10.3 Main Steam Supply System

The information in this subsection of the reference ABWR DCD, including all subsections, tables, and figures, is incorporated by reference with the following departures and supplements.

Figure 10.3-1 Main Steam Supply System

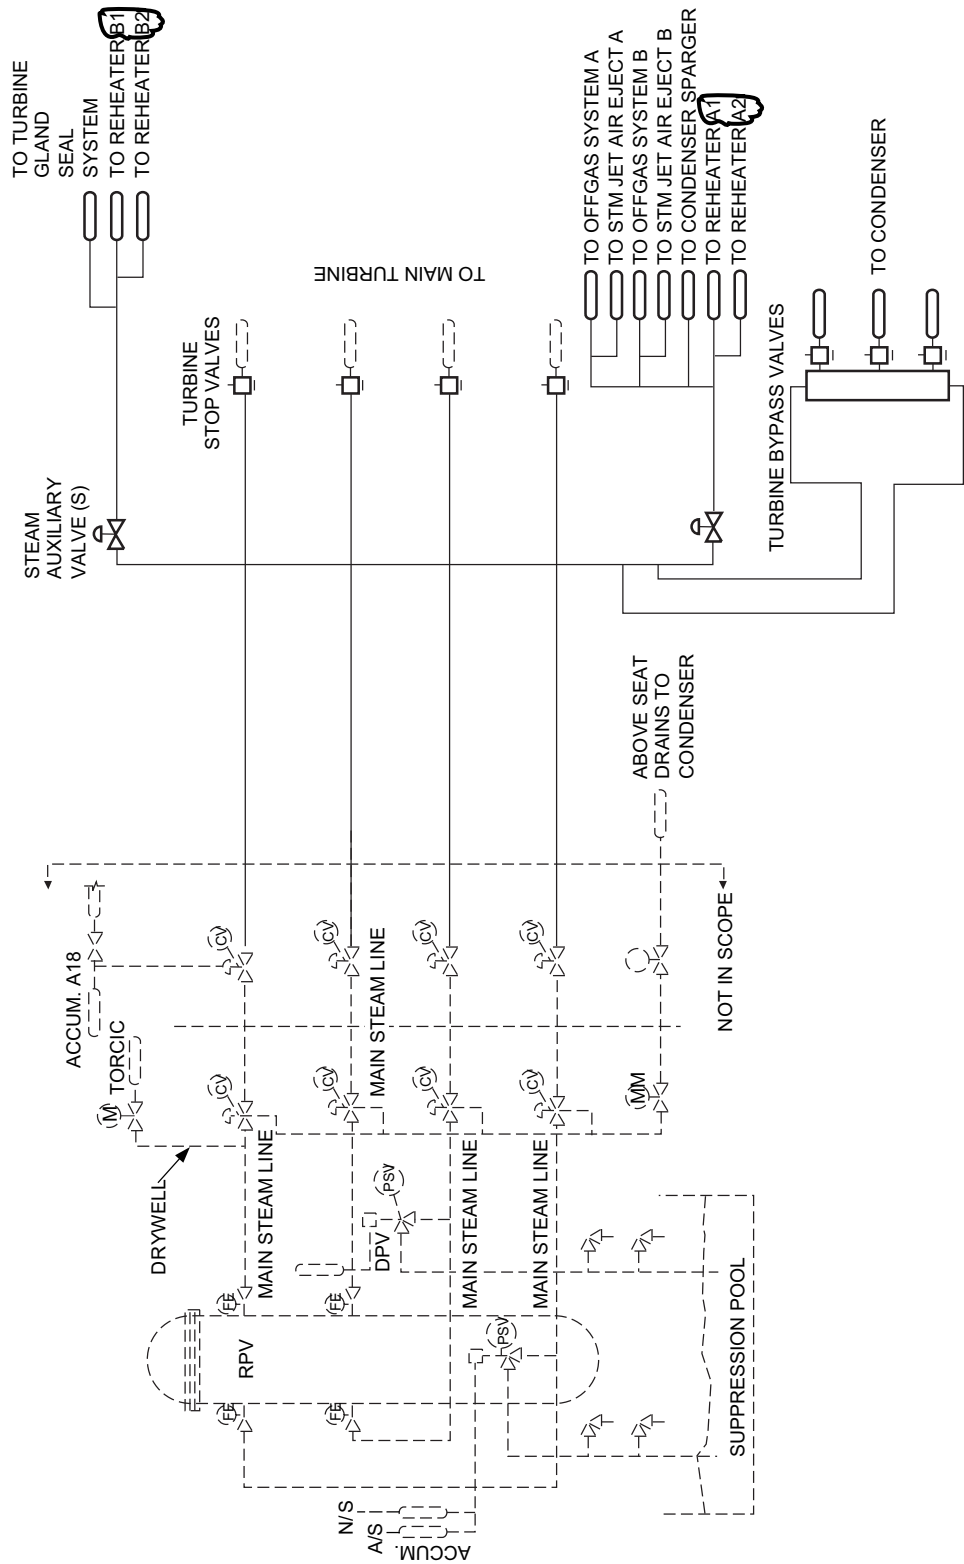
STP DEP 10.2-1 (Figures 10.3-1 and 10.3-2)

The Main Steam Supply System is illustrated in Figure 10.3-1. The system design data is provided in Table 10.3-1. The main steam piping consists of four 700A pipe size diameter lines from the outboard MSIVs to the main turbine stop valves. The four main steamlines are connected to a header upstream of the turbine stop valves to permit testing of ~~these valves the MSIVs~~ during plant operation with a minimum load reduction. This header arrangement is also provided to ensure that the turbine bypass and other main steam supplies are connected to operating steamlines and not to idle lines. The main steam process downstream of the turbine stop valves is illustrated in Figure 10.3-2.

Figure 10.3-2 Main Steam Turbine System

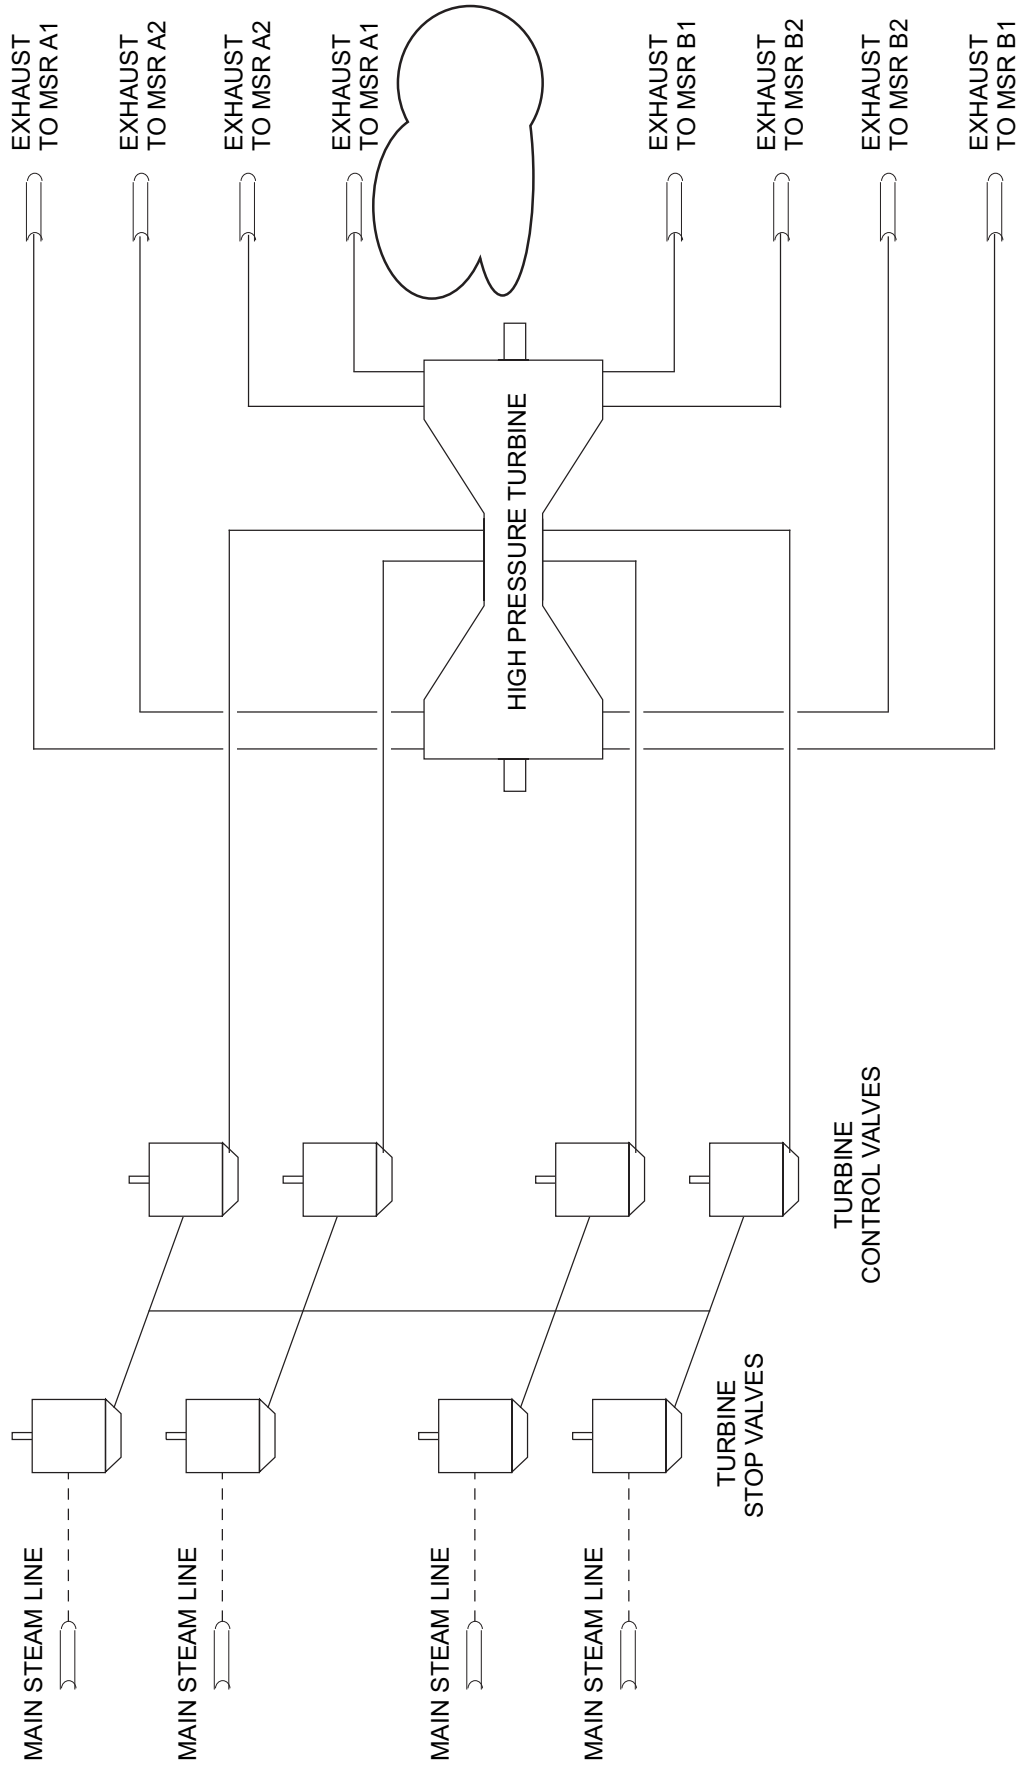
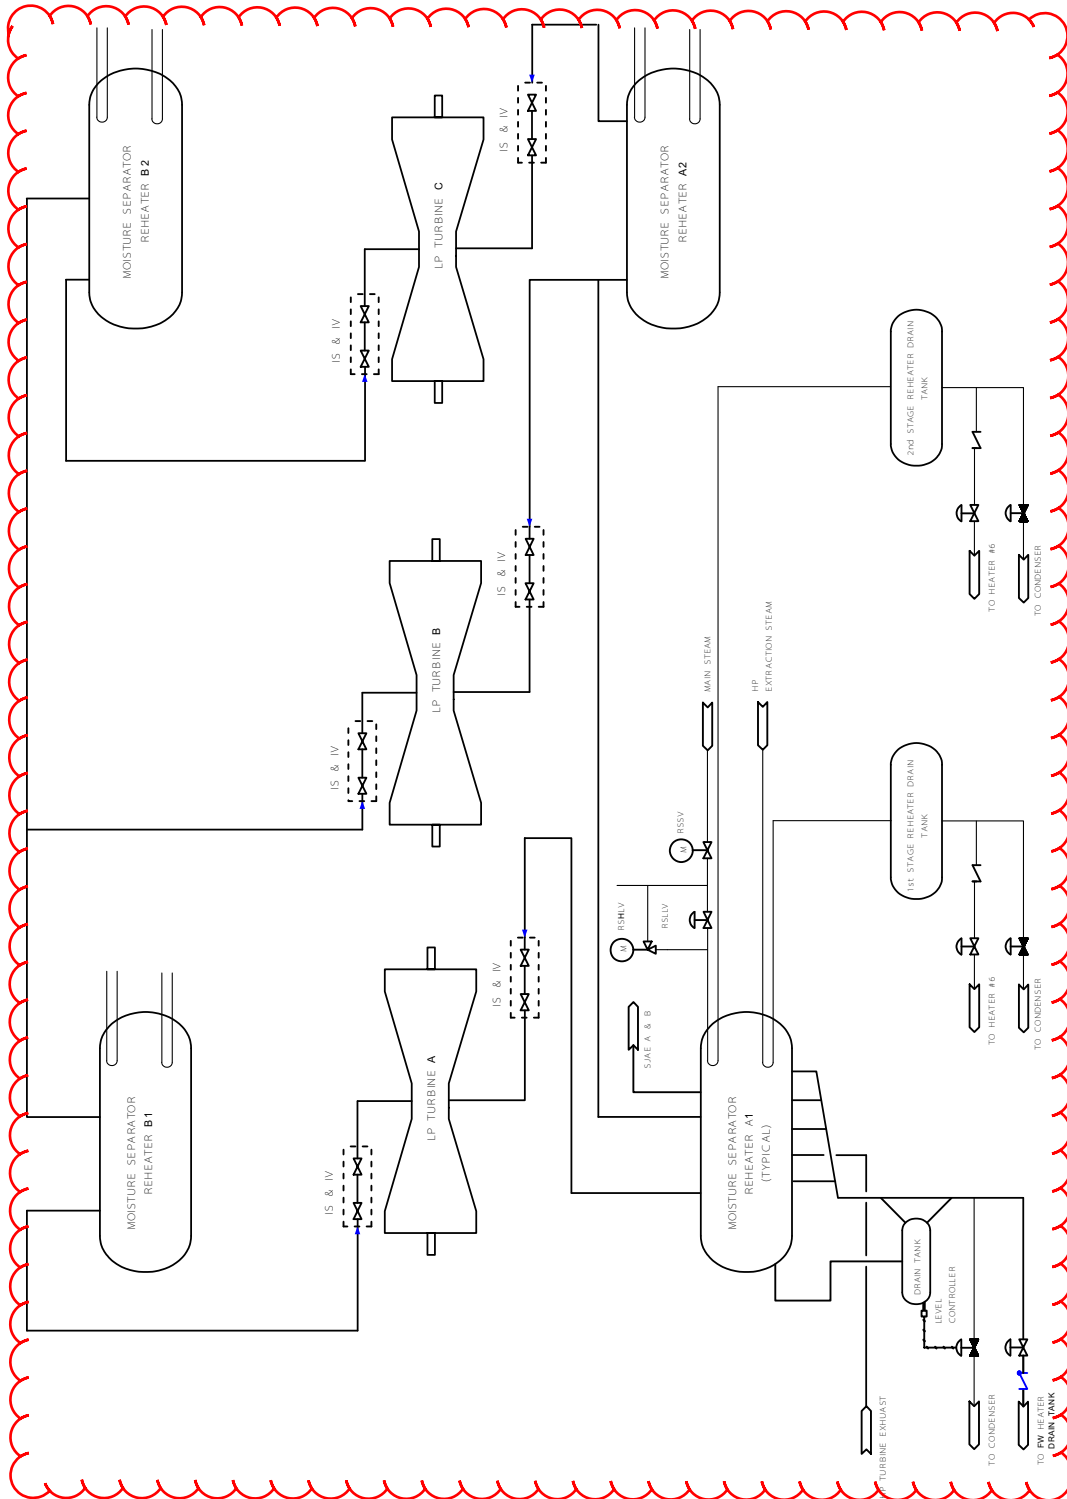
STP DEP 10.4-3 (Figure 10.3-2)
